SOLICITATION AMENDMENT

Title - Sujet Emergency Towing Vessels	
Solicitation No. - N° de l'invitation F7017-160056/C	Amendment No. - N° modif. 006
Client Reference No. - N° de référence du client F7017-160056	Date 2018-03-01
GETS Reference No. - N° de référence de SEAG PW-\$\$MB-003-26699	
File No. - N° de dossier 003mb.F7017-160056	CCC No./N° CCC - FMS No./N° VME
Solicitation Closes - L'invitation prend fin at - à 02:00 PM on - le 2018-04-05	Time Zone Fuseau horaire Eastern Standard Time EST
F.O.B. - F.A.B. Plant-Usine: <input type="checkbox"/> Destination: <input type="checkbox"/> Other-Autre: <input type="checkbox"/>	
Address Enquiries to: - Adresser toutes questions à: Aubin, Marc A.	Buyer Id - Id de l'acheteur 003mb
Telephone No. - N° de téléphone (819) 420-5452 ()	FAX No. - N° de FAX () -
Destination - of Goods, Services, and Construction: Destination - des biens, services et construction:

This Amendment number 006 is raised to (1) change the Request for Proposal closing date to the 5th of April 2018, (2) make modifications to the Request for Proposal (RFP) and (3) answer questions from the industry as follows:

Two Examples of Contrasting Stripe Border and CCG Wordmark ”

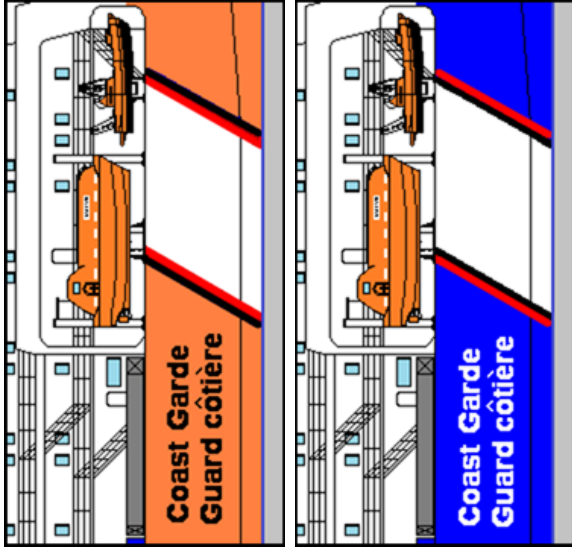
Modification #21 – Appendix D to Annex A (Data Item Deliverable (DID)) DID T-001 (Mobilisation Plan) only is deleted in its entirety and replaced with the following:

The Mobilisation Plan must describe in detail how the Contractor intends to mobilize the ETVs from their pre-contract award state and condition to meet the requirements of the vessels detailed in the Baseline Requirements document, the SOW and ConOps, including delivering a vessel painted with white diagonal hull stripe with painted contrasting borders and the "Coast Guard/Garde côtière: word mark (either painted or as a decal) on either side of the hull in a contrasting color (see examples below).

The sizing, positioning and lettering styles for the stripe and wordmark must be in accordance with the CCG Fleet Federal Identity Program Guide found in addendum 1 to the Baseline Requirements Document (Appendix A to the SOW).
